BOWMANS CREEK **WIND FARM**
Response to Additional Information Request

Bowmans Creek Wind Farm LVIA (SSD-10315) response to DPIE request for additional information

Additional Information for Visual Assessment:

Figure 1 Lot 40 DP 1094039

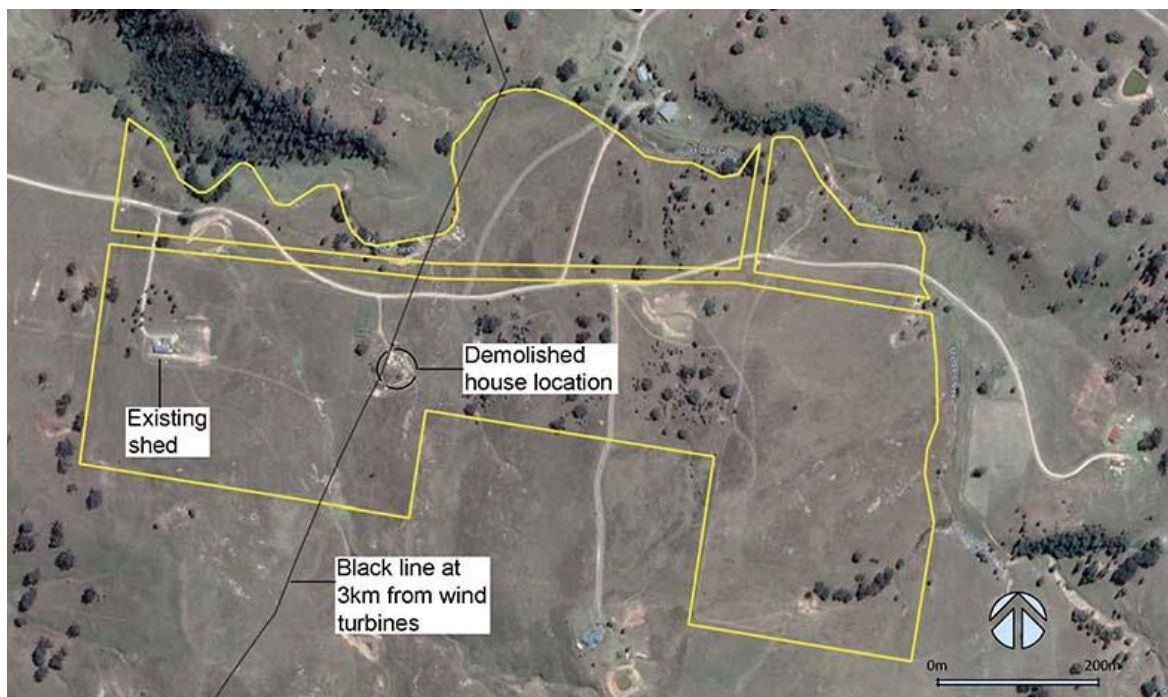
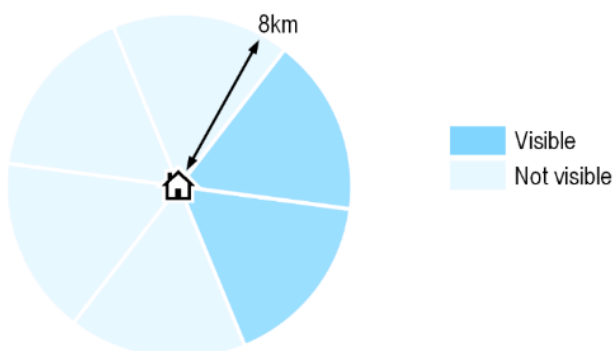
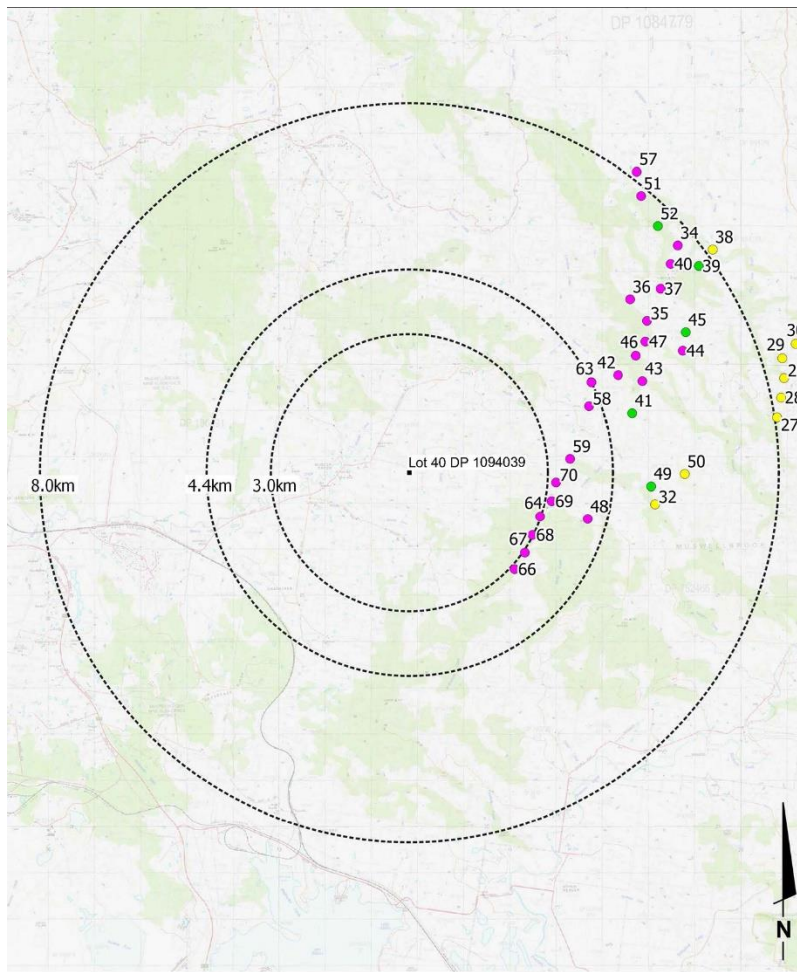
DPIE request: consideration of visual impacts on Lot 40 DP 1094039**Response 7**

Figure 2 illustrates wind turbines would be visible within 2 60-degree sectors as modelled from the site of the former dwelling. The wind turbine configuration and distance to wind turbines would also result in views being confined to 2-60 degree sectors if any future dwelling was to be located to the east of the former dwelling site or in any other portion of the Lot. This is also confirmed by dwelling G17-1 located to the east of the Lot which has wind turbine visibility limited to 2 60-degree sectors.

Figure 3 illustrates a Multiple Wind Turbine Tool diagram as modelled from the site of the former dwelling.

Any dwelling, if approved, could be located to the west of, and beyond the black line and be orientated to capture main views to the north and west away from most wind turbines. As such the potential visual impact could be mitigated and is not considered significant. Recommended conditions of consent, including the provision of landscape mitigation would further reduce the significance of visual impacts should a dwelling be built in the future.

Cross Section F17-1 – T59 location plan

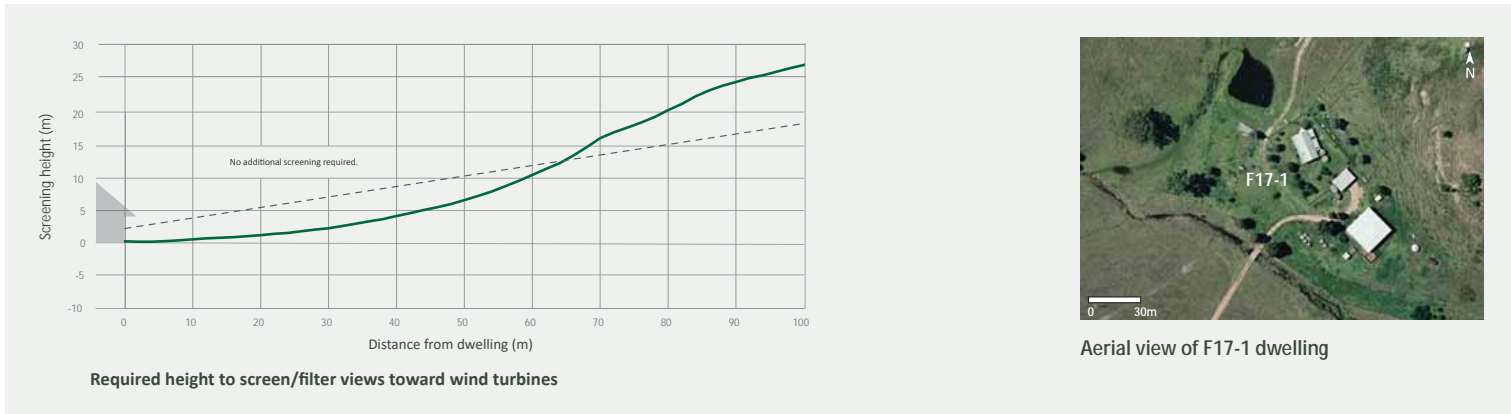
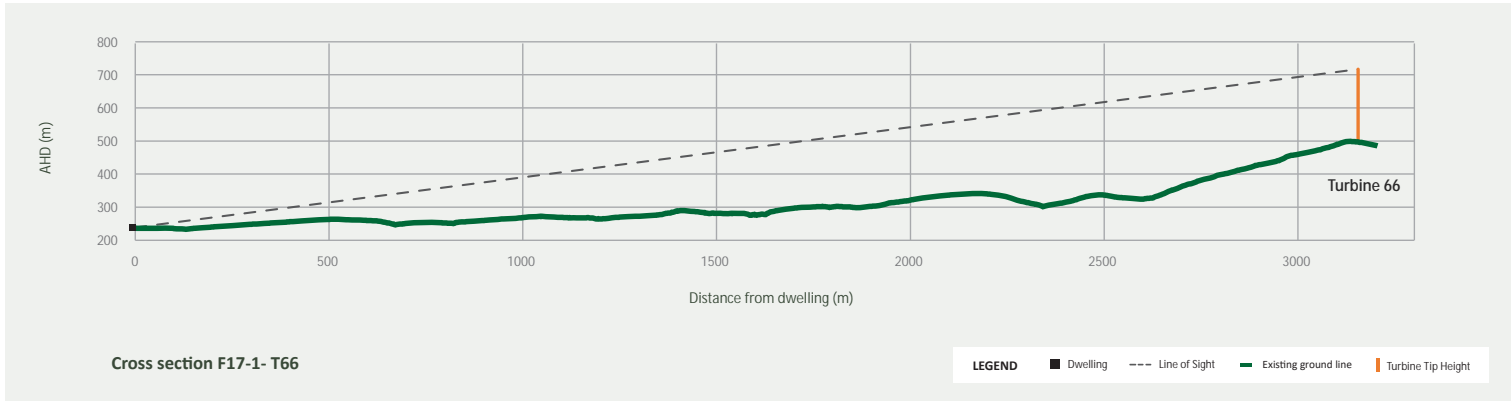
Existing trees surrounding and beyond dwelling F17-1 will provide some degree of screening and filtering of views toward turbines within the west and north west portion of the project. Additional spot planting beyond the dwelling would assist in screening/filtering views toward turbines in the south west portion of the project.

The wind farm would not result in a significant visual impact at dwelling F17-1.

Cross Section F18-1 – T59 location plan

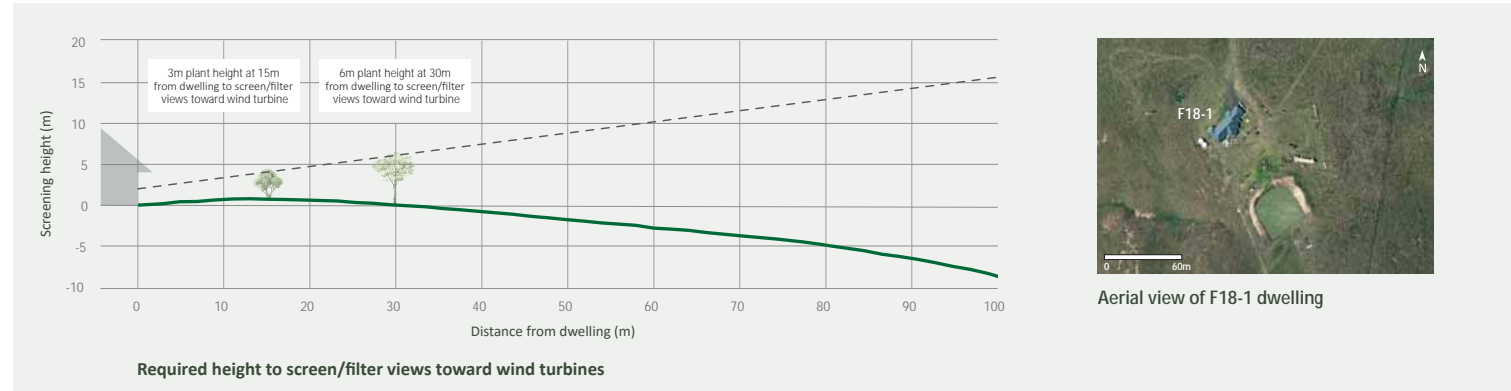
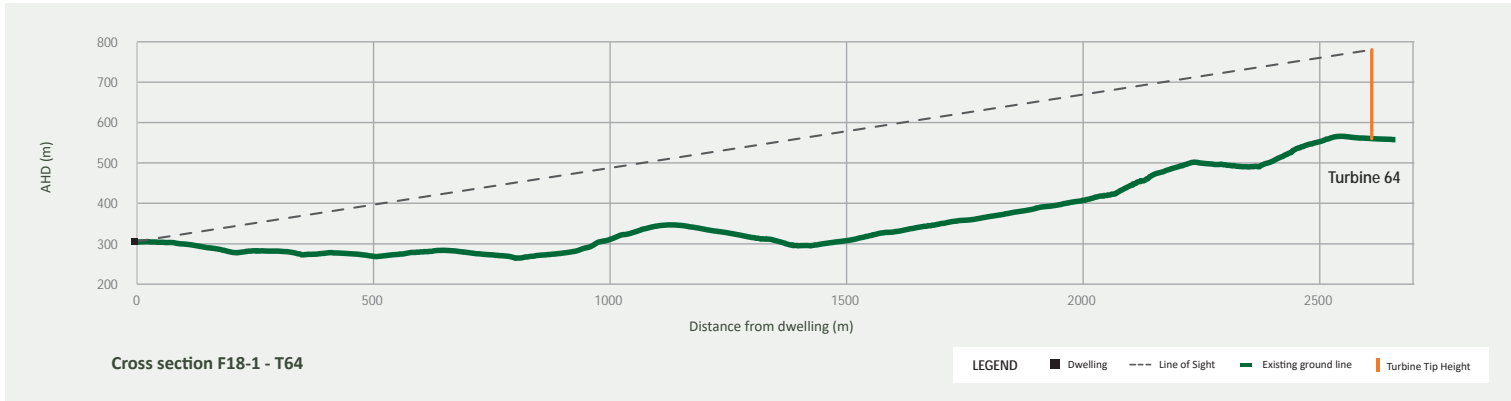
There is limited tree planting around the dwelling to screen views toward turbines which would be visually prominent on an elevated ridgeline east of the dwelling. A cross section analysis has determined that screen planting between 6m and 7m in height at 30m from the dwelling would provide effective screening toward wind turbines.

Without screening, the turbines would have potential to result in a significant visual impact at dwelling F18-1. With screening the wind turbines would not have a significant visual impact at dwelling F18-1.

Cross Section F18-1 – T64 location plan

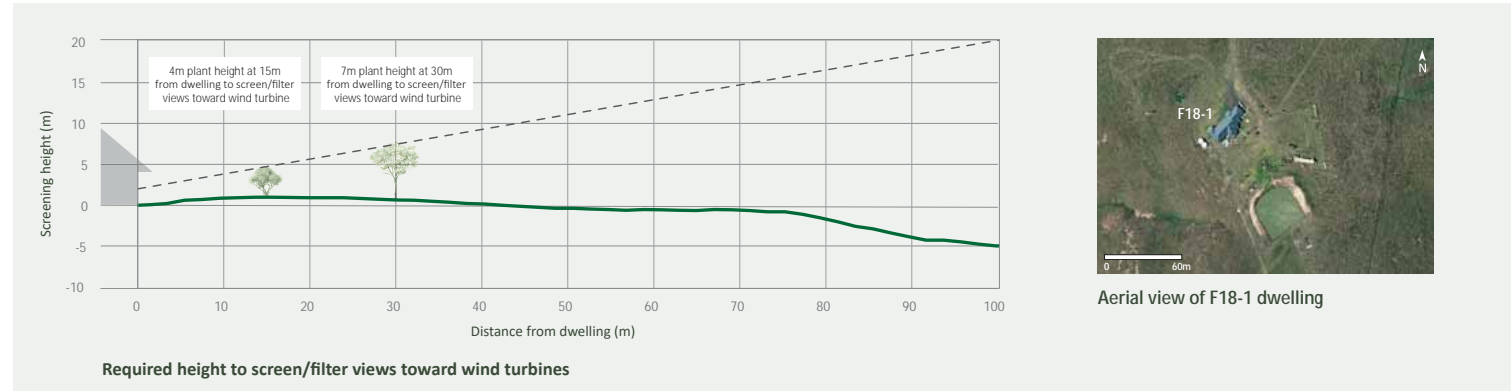
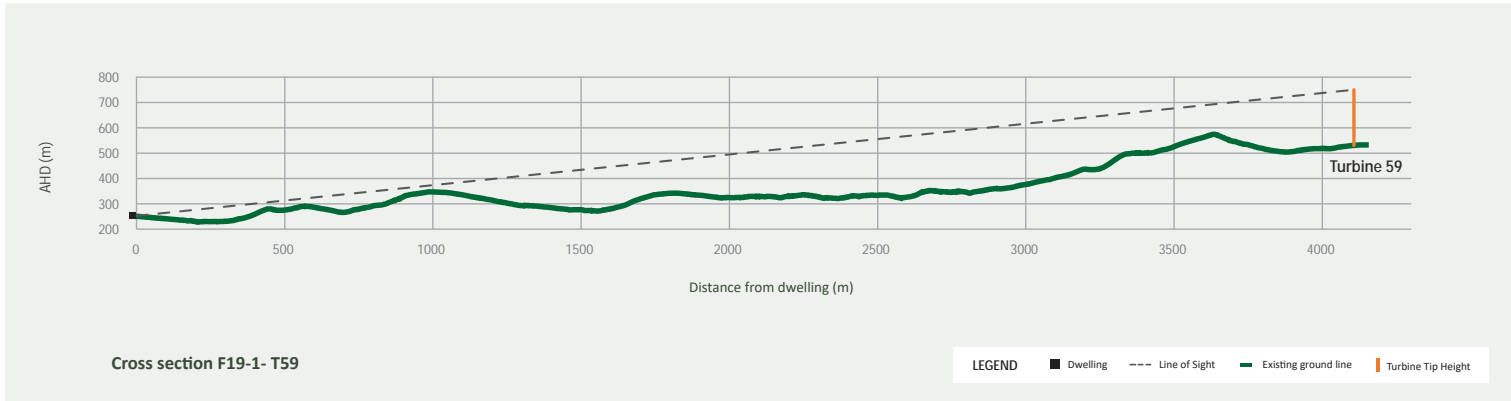
There is limited tree planting around the dwelling to screen views toward turbines which would be visually prominent on an elevated ridgeline east of the dwelling. A cross section analysis has determined that screen planting between 6m and 7m in height at 30m from the dwelling would provide effective screening toward wind turbines.

Without screening, the turbines would have potential to result in a significant visual impact at dwelling F18-1. With screening the wind turbines would not have a significant visual impact at dwelling F18-1.

Cross Section F19-1– T59 location plan

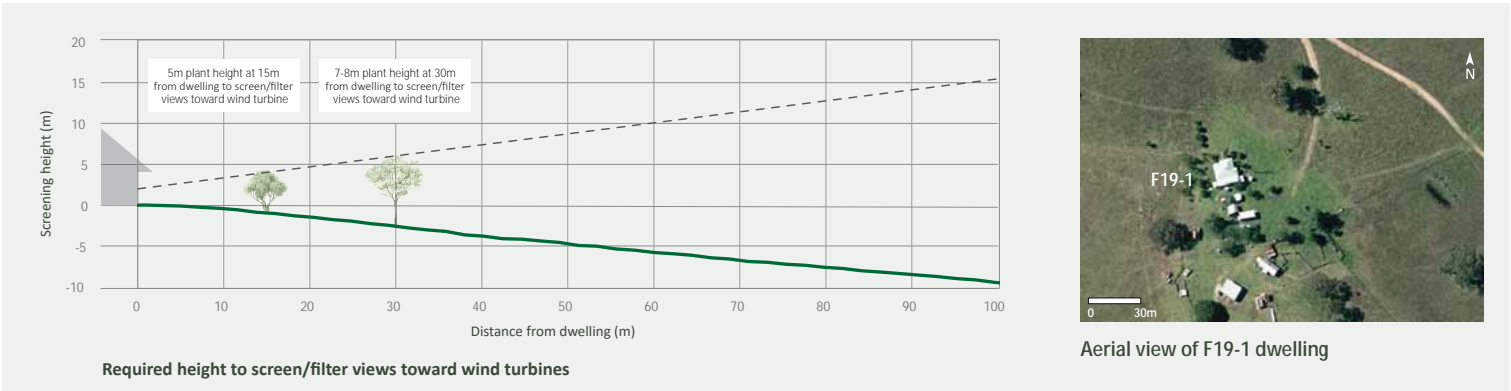
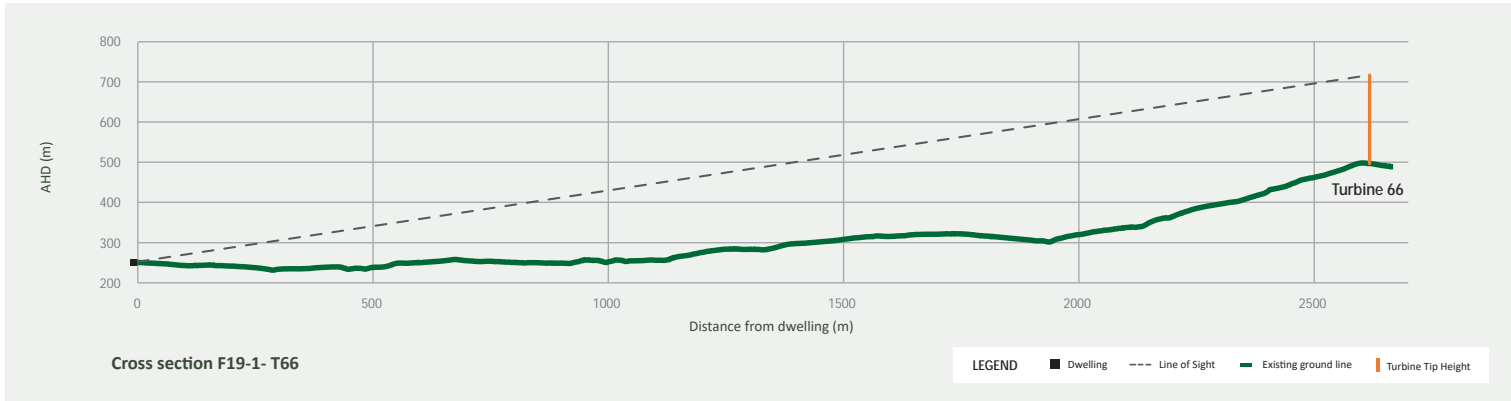
Residual impacts
The photomontage prepared for dwelling F19-1 illustrates direct and open views toward turbines on an elevated ridgeline east of dwelling F19-1. A cross section analysis has determined that screen planting between 7m and 8m in height at 30m from the dwelling would provide screening toward wind turbines.

Visual significance
Without screening the turbines would have potential to result in a significant visual impact as dwelling F19-1. With screening the wind turbines would not have a significant visual impact at dwelling F19-1.

Cross Section F19-1– T66 location plan

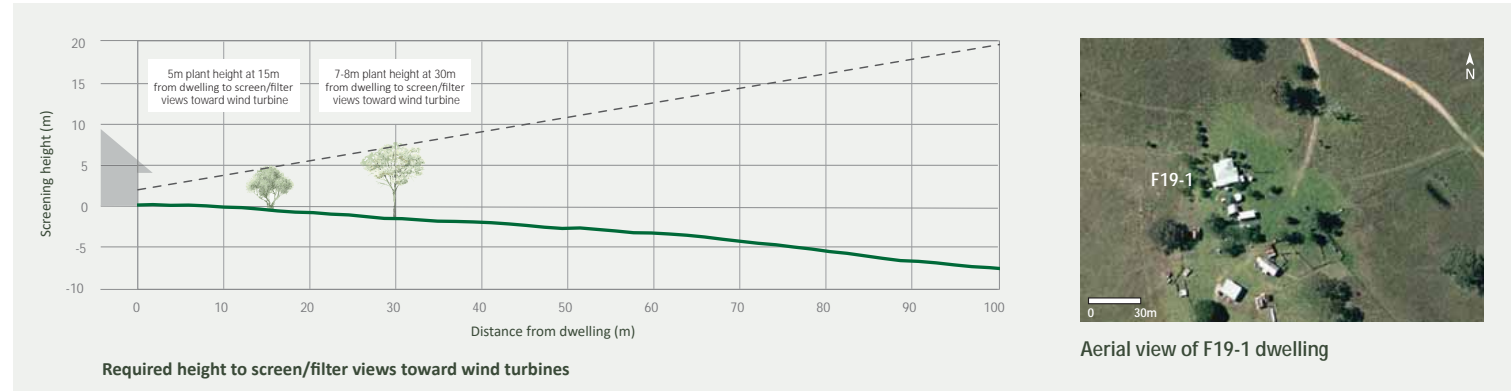
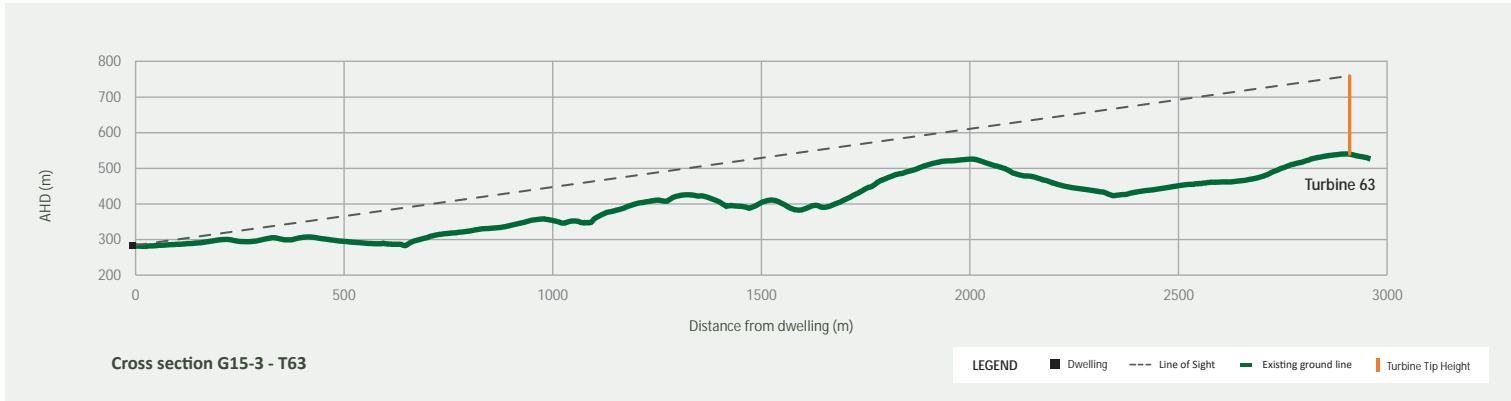
The photomontage prepared for dwelling F19-1 illustrates direct and open views toward turbines on an elevated ridgeline east of dwelling F19-1. A cross section analysis has determined that screen planting between 7m and 8m in height at 30m from the dwelling would provide screening toward wind turbines.

Without screening the turbines would have potential to result in a significant visual impact as dwelling F19-1. With screening the wind turbines would not have a significant visual impact at dwelling F19-1.

Cross Section G15-3 – T63 location plan

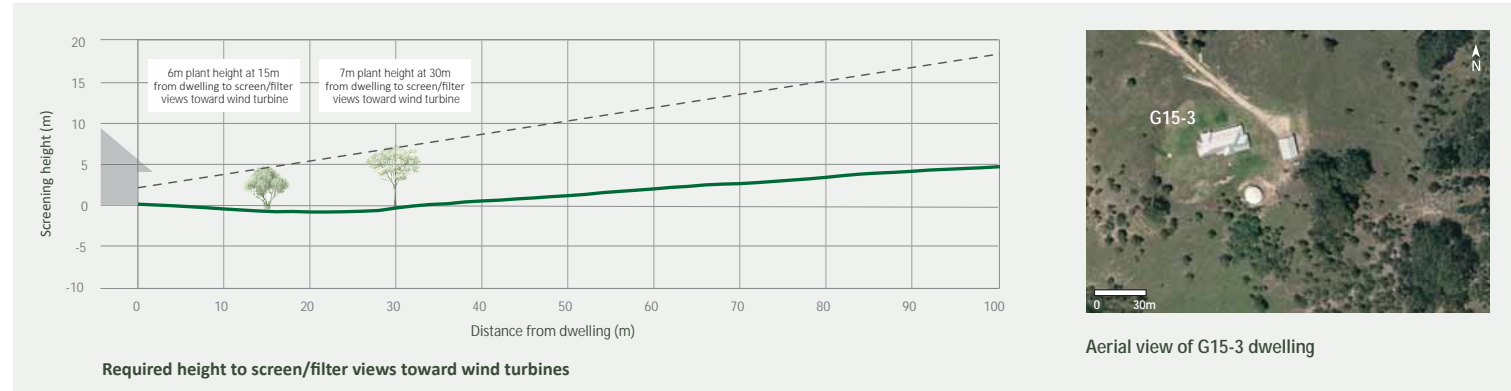
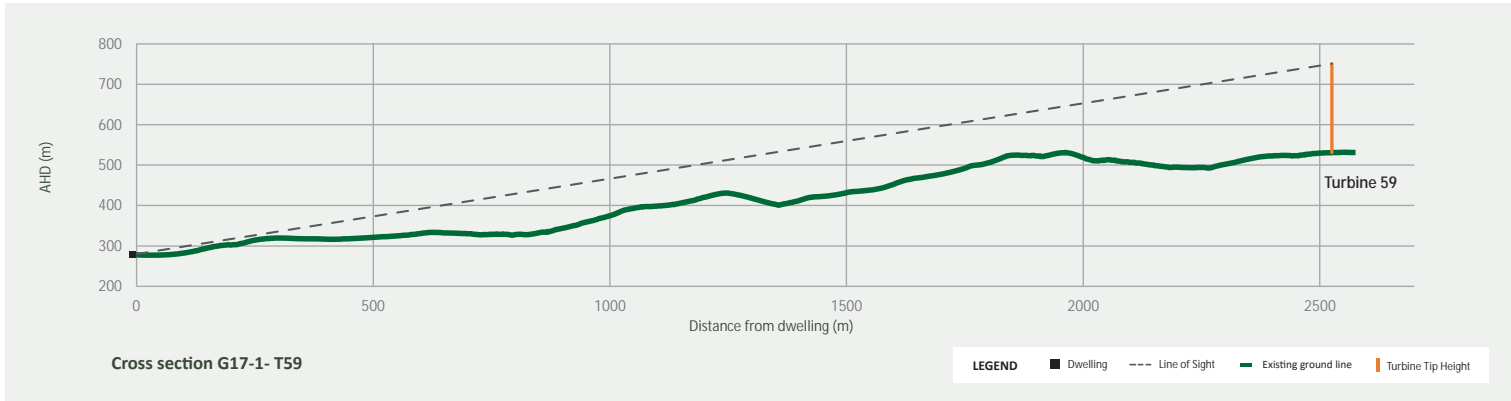
Residual impacts
Views toward wind turbines are largely screened by extensive tree cover beyond dwelling G15-3. Existing semi mature eucalypt trees screen significant views toward wind turbines. Screen planting is not considered necessary but would be made available if requested. A cross section analysis has determined that screen planting around 7m in height at 30m from the dwelling would provide screening toward wind turbines.

Visual significance
The wind farm would not result in a significant visual impact at dwelling G15-3.
